STATE OF NORTH CAROLINA  
DEPARTMENT OF TRANSPORTATION

February 25, 2005

Subject: **404 Individual Permit and 401 Water Quality Certification Modification**  
**Request** for Hope Mills Bypass from SR 1141 to SR 1132, Cumberland County,  
Federal Aid Project No. STP-0622(2), State Project No. 8.2623601, TIP No. U-  
620, NCDOT Division 6, \$475 Debit WBS Element 34760.1.1.

### PLAN VIEW SITE 2

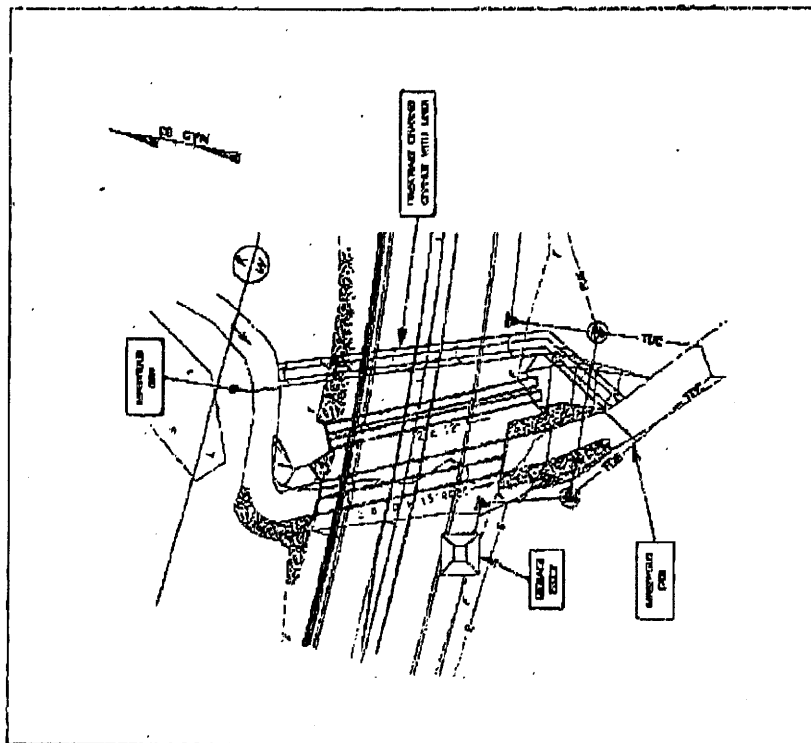
**Site 2 (Station 106+32):**

A 130 LF twin 10' x 13' RCBC/30 LF end wall is proposed along with a 150 LF twin 72" culvert to convey Buckhead Creek and the associated flood flows. The actual permit drawings did not address the temporary diversion channel, which is necessary to ensure a dry worksite for the culvert construction and isolation of the fresh concrete from the live channel. The diversion will be installed in accordance with the NCDOT BMP Manual Section 5.2.4. The culvert construction sequence is contained on Sheet EC-11 within the final construction plans. Barnhill Contracting Co. has suggested utilizing driven sheeting to provide the impervious dike, but, this methodology may change as the project progresses. Approximately 60 ft of temporary stream channel side slopes will be disturbed in the installation of the diversion channel. The impacts are temporary, and, once the diversion channel is eliminated, all disturbed areas shall be stabilized.

**This accounts for an increase of 60 ft of temporary stream impacts.**

**PLAN VIEW**  
**SITE 3**

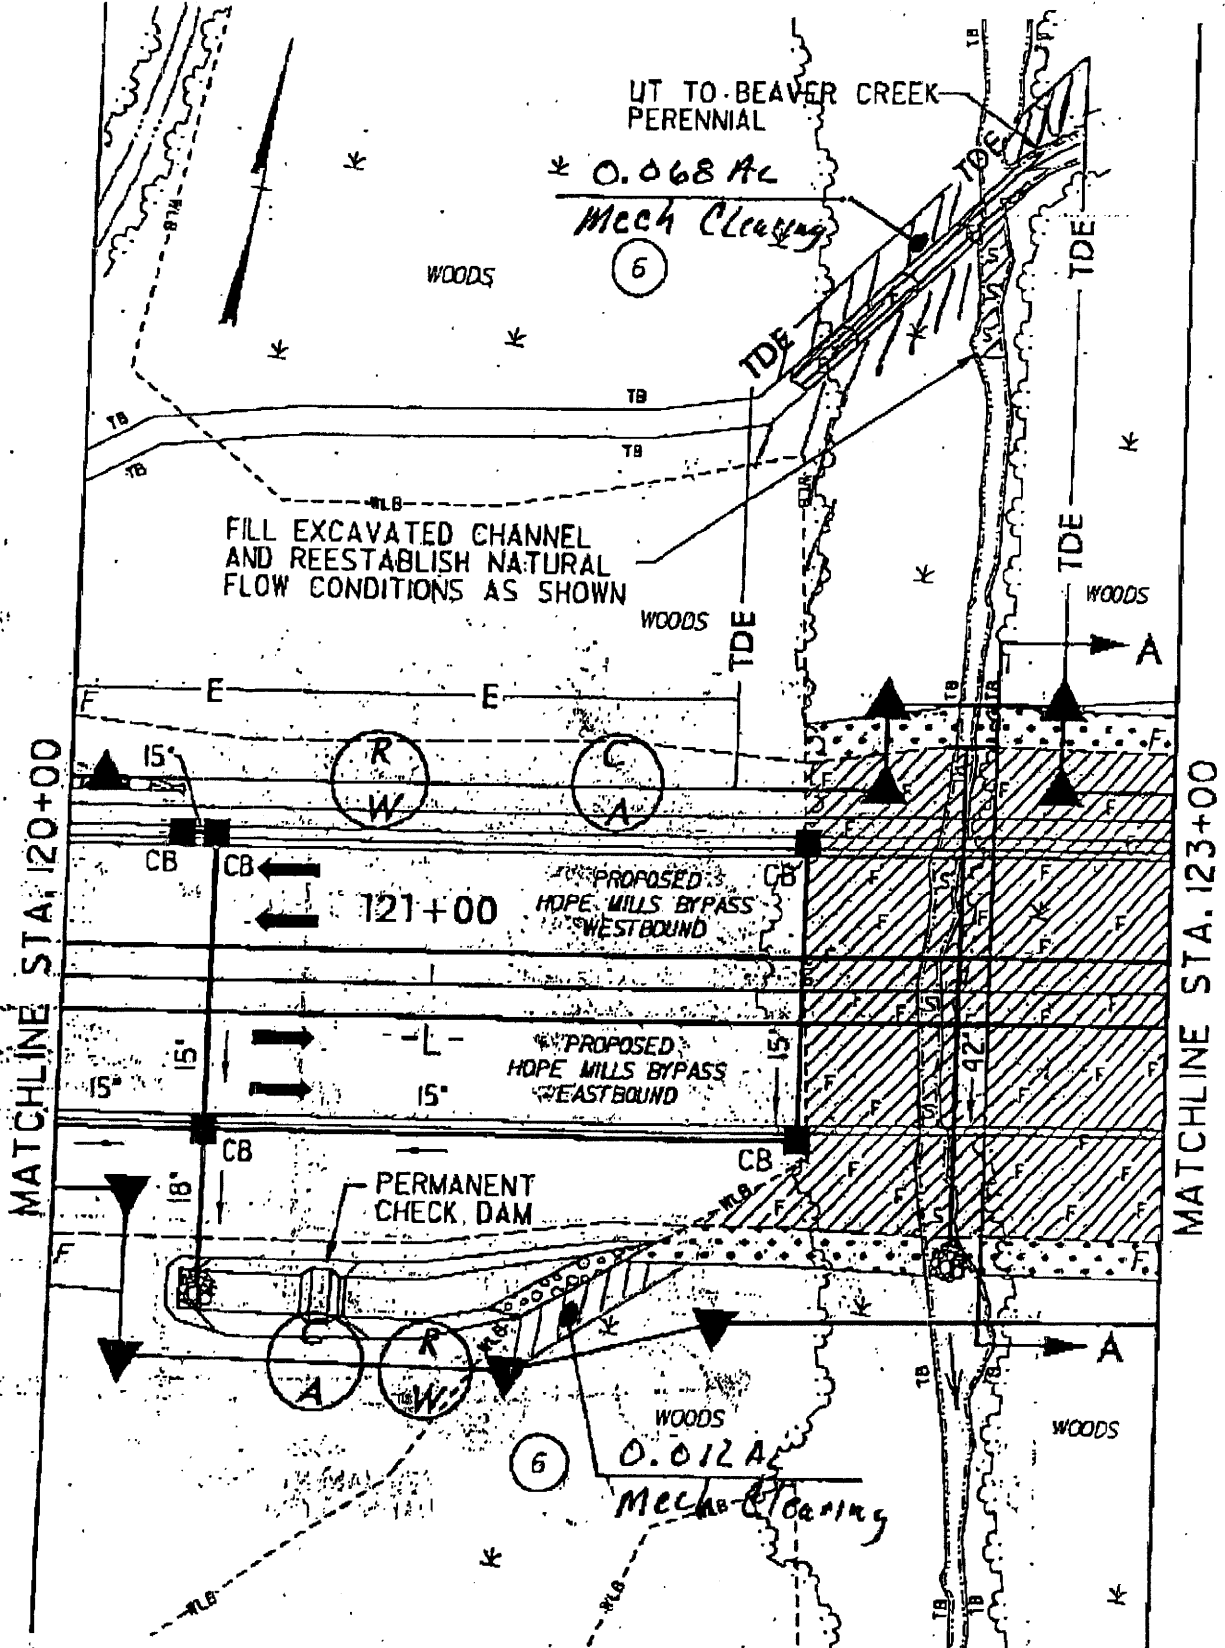
**Site 3 (Station 121+56 to 125+73 –L-):**

This site requires an additional 0.08 ac of mechanized clearing in order to complete the stream diversion. The permit drawing demonstrates that the stream channel work is enclosed within a Temporary Drainage Easement (TDE). It is not possible to complete the required work without the additional mechanized clearing. Once the area is mechanized cleared, and the stream channel work completed, the excess mechanized clearing area (0.08 ac) will be reforested within the required planting season. **This accounts for an increase of 0.08 ac of permanent wetland impacts.**

## Str #2 & #3 over CSX Railroad

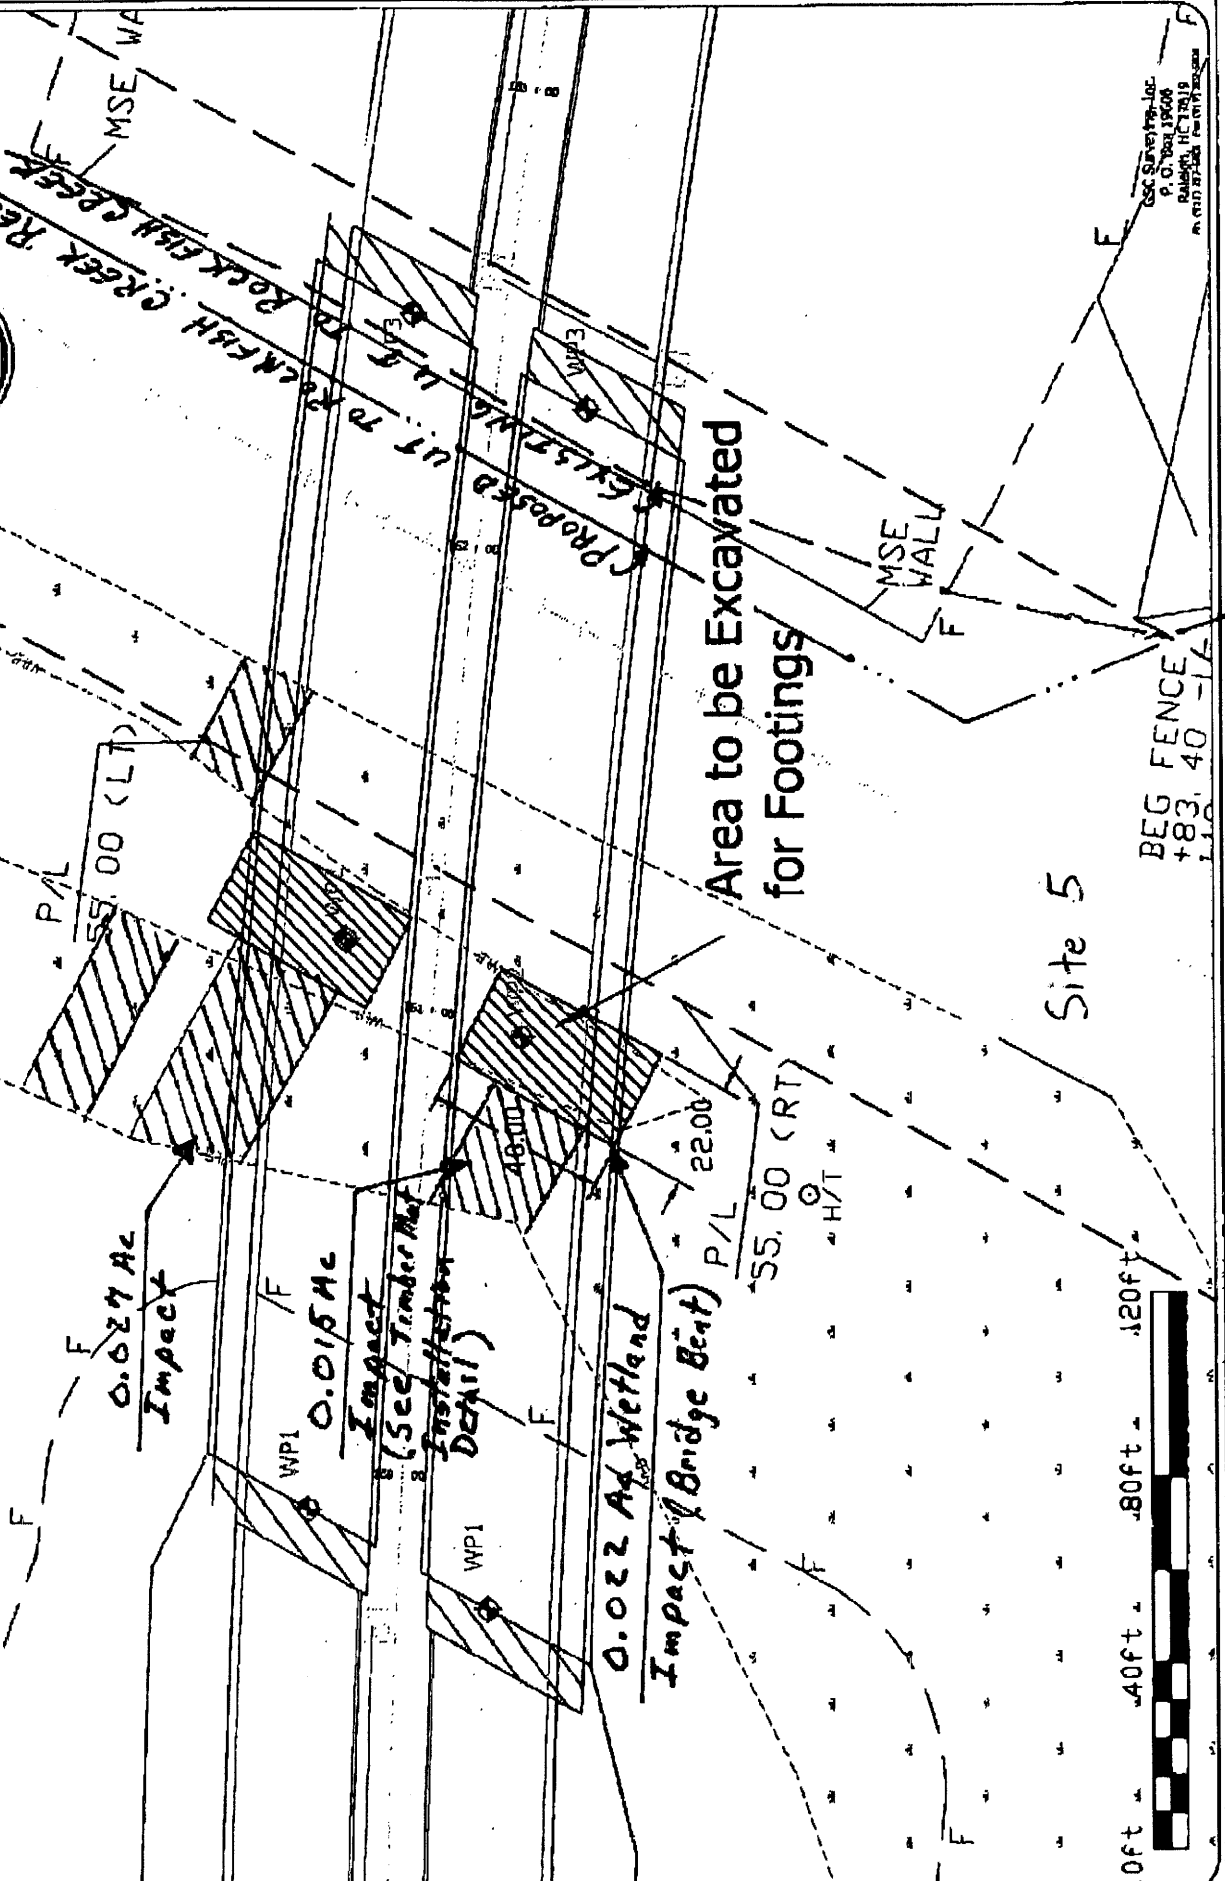
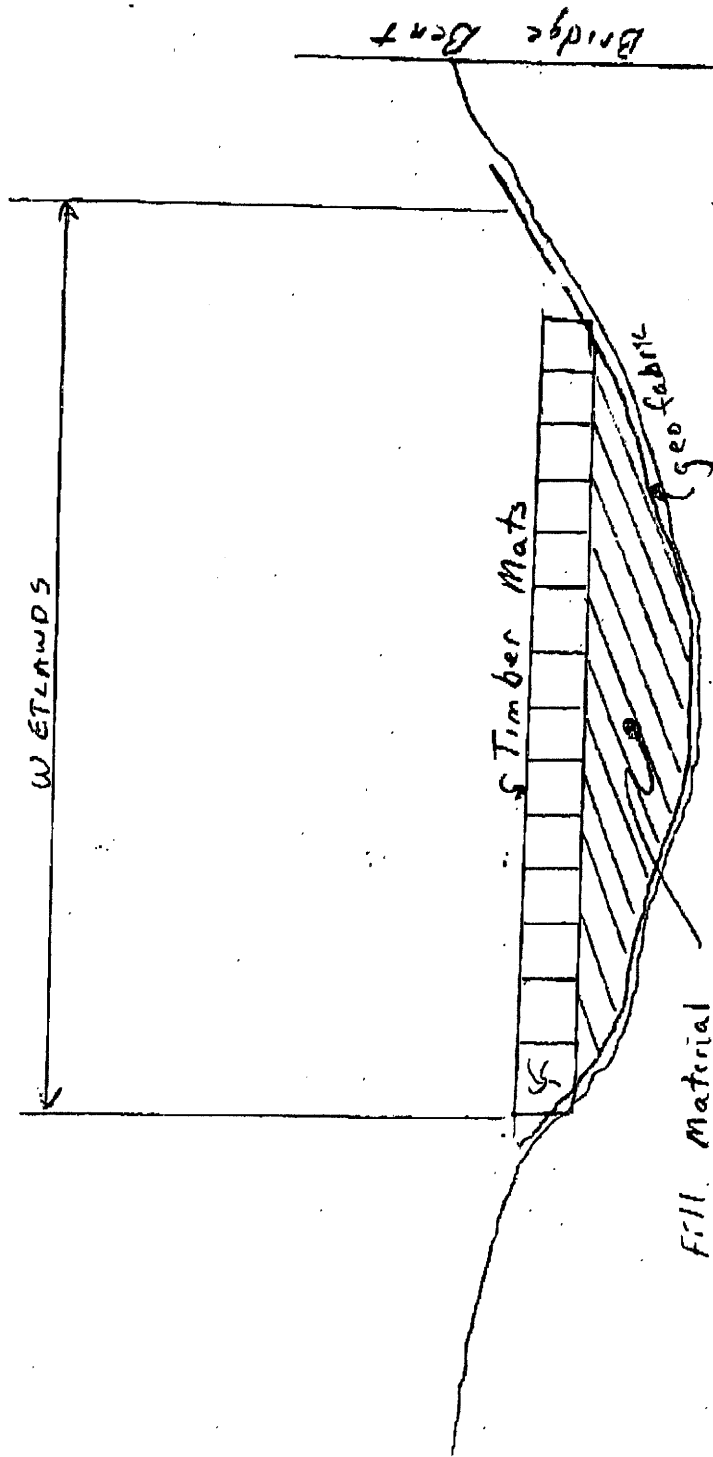
This site includes the proposed bridge location over the CSX rail line. Within this area, the proposed bridge bents were laid out on the ground to determine the exact impact to the jurisdictional areas. The enclosed drawing (1 in=40 ft) demonstrates the 0.02 ac of permanent impact. **This accounts for an increase of 0.02 ac of permanent wetland impacts.**

When laying out the eastern side of the CSX bridge, it has been identified that the CSX ditch (UT to Rockfish Creek) has encroached upon the proposed MSE (Mechanically Stabilized Earthen) wall. The UT to Rockfish Creek is an intermittent channel. The channel will be relocated approximately 300 ft back to the location in which it was shown on the permit plans (Site 5). In looking at the condition of the channel, there are a couple of reasons why the channel relocated itself: CSX ballast stone maintenance and debris placed in channel. Ballast stone has relocated down the slope and the roughness of the ballast stone caused the channel to relocate. In addition to the ballast stone situation, railroad debris was noted in the channel. A few railroad ties and a large truck tire were seen in the channel. The channel is not that large, typically 2-3 ft wide with a depth of 1 ft. Additionally, since this channel is located along a rail line, the slope is marginal. The channel will be relocated to its previous location in the dry and once relocated, the stream will be directed into the relocated channel. Richard Spencer stated that impacts to this stream do not require mitigation. Approximately 300 ft of the existing stream will be filled in. The new, relocated channel will be approximately 330 ft in length. **This accounts for an increase of 300 ft of permanent stream impacts.**

Timber Mat Installation

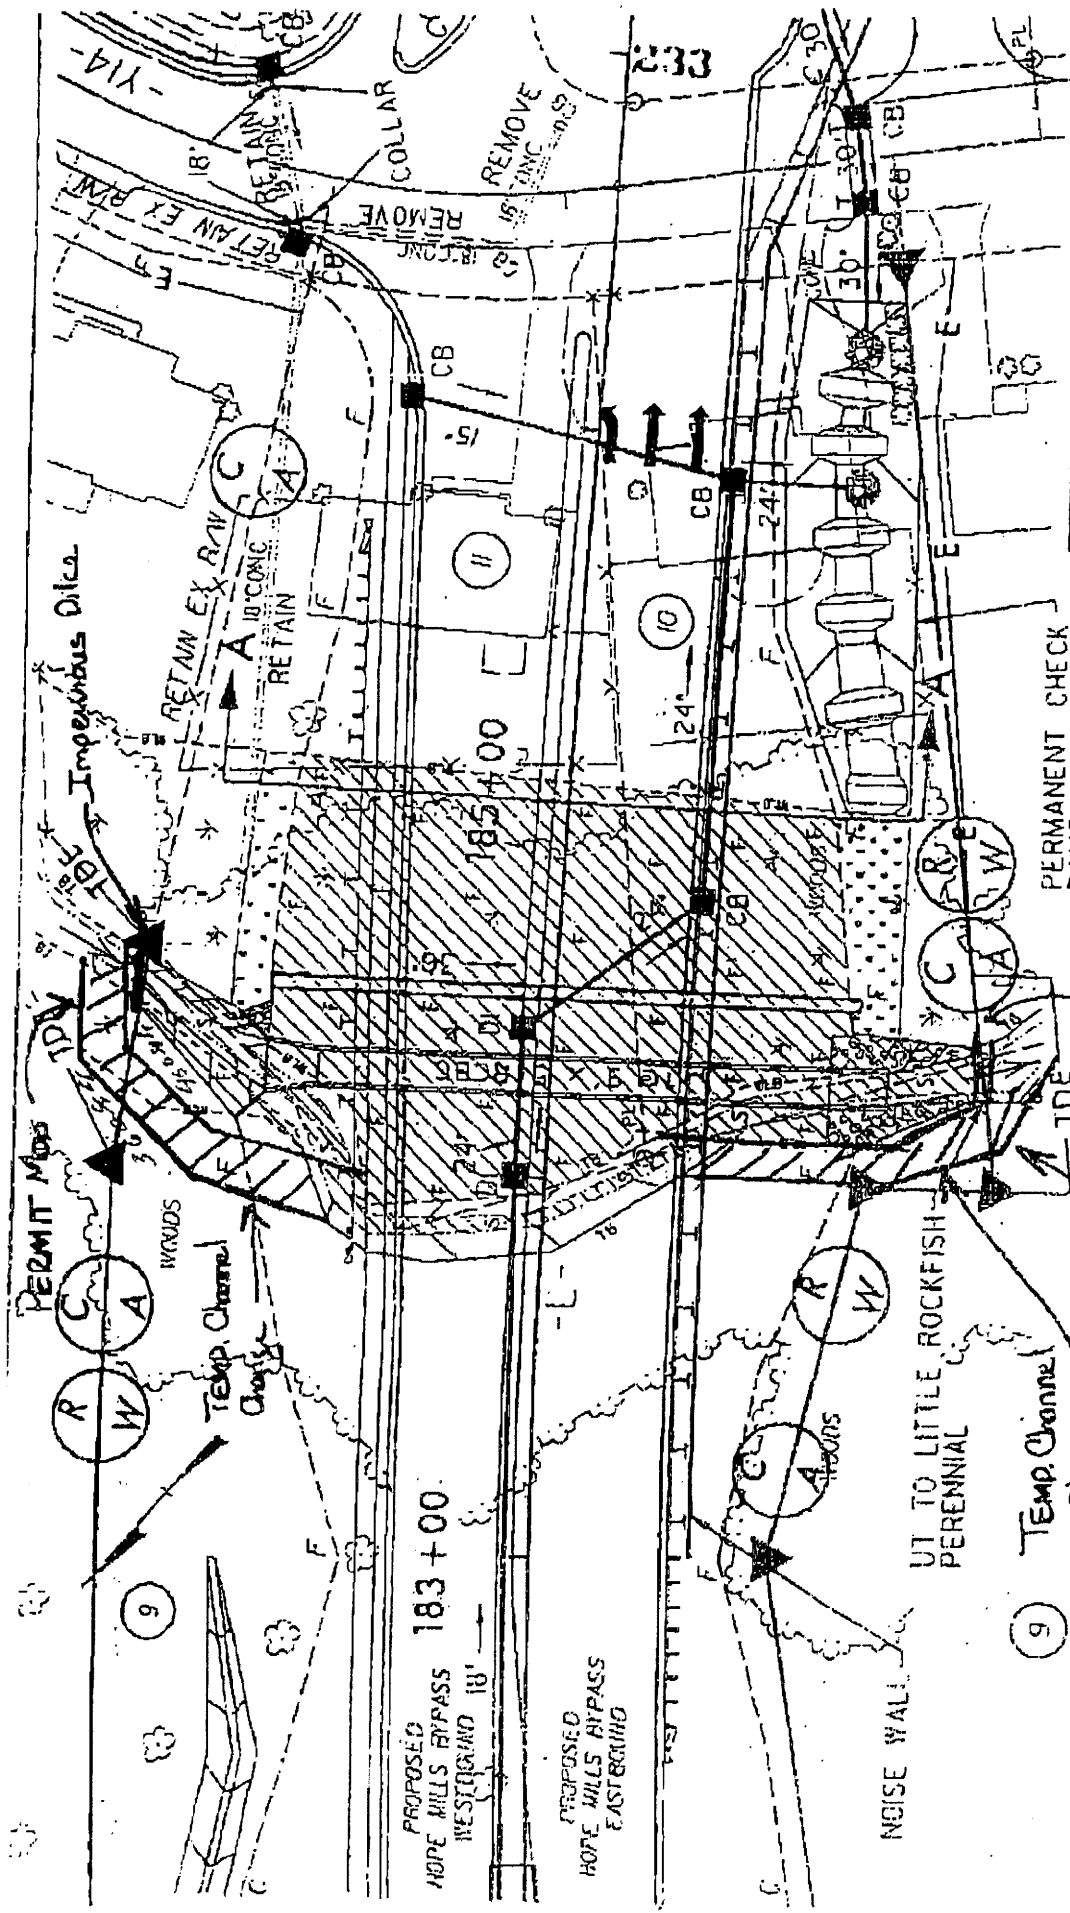
Though the timber mats were illustrated upon the permit drawings, the arrangement of the timber mats must be revised to ensure a safe and efficient worksite. In discussing the proposed revisions in the field with Richard Spencer (COE) and Ken Averitte (DWQ) on January 12, 2005, the bridge sub-contractor expressed the need to place geofabric and a layer of fill material down prior to placing the timber mats to ensure a level pad for the crane. The need for the leveling is necessary due to expected crane movements (swings) that could yield unsafe conditions. The enclosed plan demonstrates the proposed timber mat layout. The total temporary wetland impact will be 0.04 ac. Upon completion of the proposed bridge work, the timber mats shall be removed along with all fill material. The geofabric will ensure that all fill material will be removed entirely. **This accounts for an increase of 0.04 ac of temporary wetland impacts.**

# CULVERT CONSTRUCTION SEQUENCE (STA. 184 + 27)

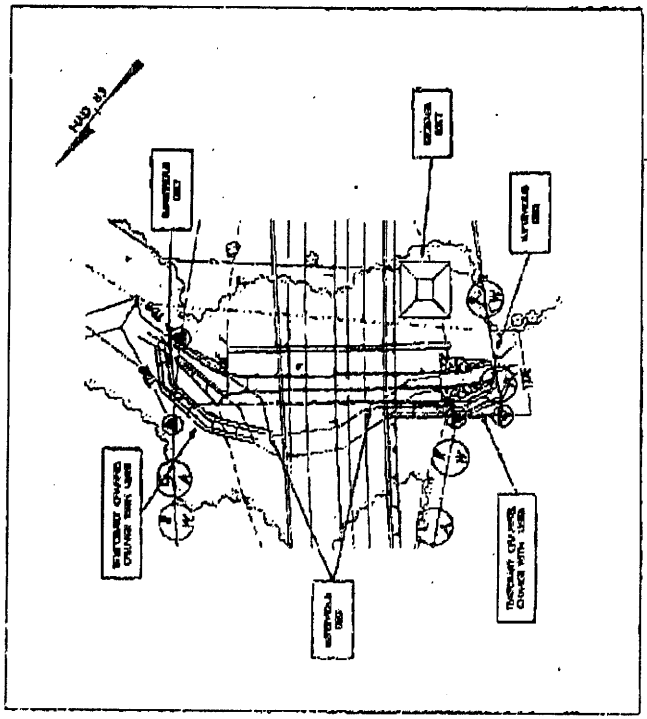
**Site 6 (Station 183+85 to 185+08 –L-):**

This site requires the installation of a temporary diversion channel to convey the expected flows around the 9'x5' RCBC and 36" CMP overflow pipe. The diversion channel for Site 6 was not within the permit drawing, but it does appear upon Sheet EC-19 of the final construction plans. The diversion channel will be installed in accordance with the NCDOT BMP Manual Section 5.2.4. An impervious dike (potentially sheeting) will be installed and 60 ft of stream bank will

be disturbed as a result. Additional mechanized clearing (0.02 ac permanent wetland impacts) must be completed in the area of the proposed diversion channel. The additional area of mechanized clearing includes the 0.01 ac of disturbance from the actual installation of the diversion channel. Upon completion of the culvert, the diversion channel will be backfilled, original grades re-established, and the area will be reforested. **This accounts for an increase of 60 ft of temporary stream impacts and 0.02 ac of permanent wetland impacts.**
